Service - Info

Unit type : STV510, STV515, STV550, STV552, STV5187.1, STV5197.1, Scenaro 215
Chassis : 11AK19E-3 Mono

No.: 258

Concern: Chuckling noise in the stand by mode audible at the loudspeaker.

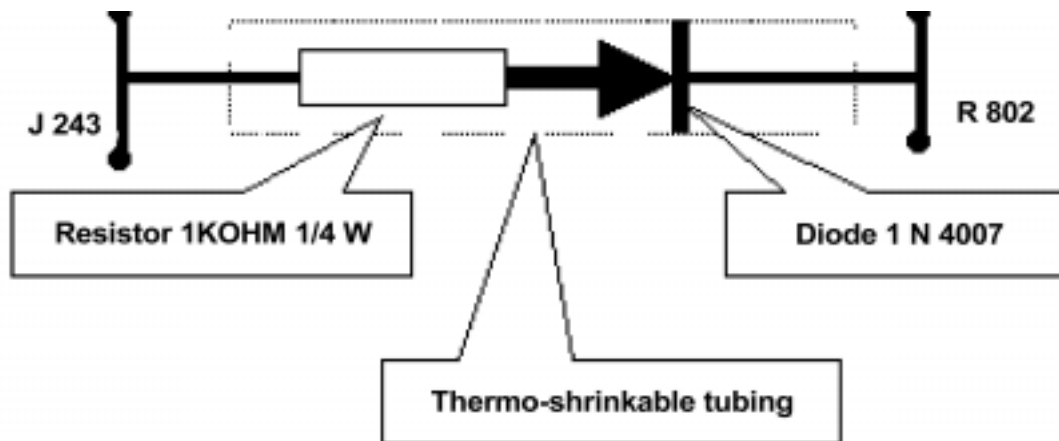
- 1.) The thyristor in position Q810 has to be replaced.
- 2.) The chip capacitor in position C 806 has to be removed and replaced by a foil capacitor (33nF/100V) between pin 4 to pin 6 of IC 802 (power supply unit).
- 3.) The fuse resistor in position R867 has to be changed from 0,33Ω / **1/4W** into a 0,33Ω / **1/2W** version.
- 4.) Additional at the underside of the main board a resistor 1KΩ / 1/4W and a diode 1N4007 have to be applied between the jumper J243 and jumper R802 alike the below declared sketch:

Spare part number	Thyristor Q810:	0105509
	Foil capacitor 33nF/100V:	0061259
	Resistor 0.33Ω / 1/2W:	0031686
	Resistor 1KΩ / 1/4W:	0010073
	Diode 1N4007:	0031811
